TECHNICAL SERVICE BULLETIN

SUBJECT: FRONT PINION SHAFT OIL SEAL LEAKAGE -
1960-63 CORVAIR W/POWERGLIDE

BULLETIN NO. TSB #886
DR #590
SECTION IV

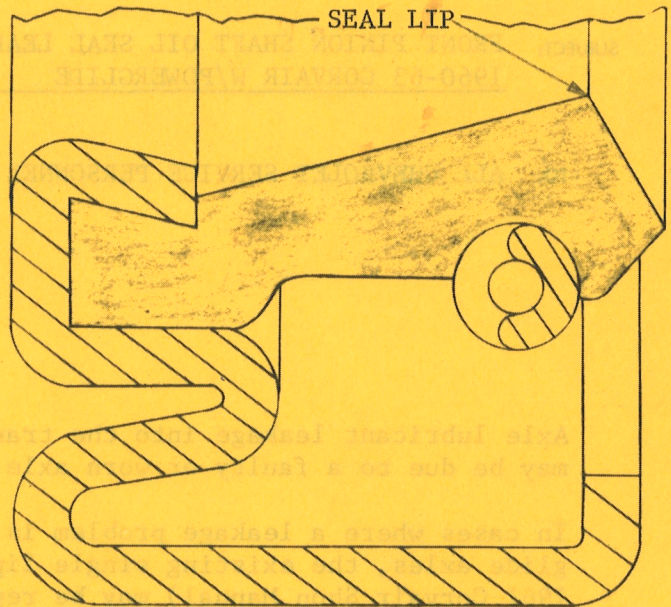
In cases where a leakage problem is encountered on 1962 Powerglide axles, the existing single lip seal (Page 6C4, Item 4 - 1961 Corvaire Shop Manual) may be replaced with Part No. 3813621 double lip seal. On 1960-61 Powerglide axles, the existing Part No. 6256074 single lip seal should be installed with the lip pointed toward the axle as shown on Page 2 of this Bulletin.

Sealing lip with garter spring must be installed toward axle -
 Both type seals. Care should be taken when installing the seal
 not to distort the metal seal housing.
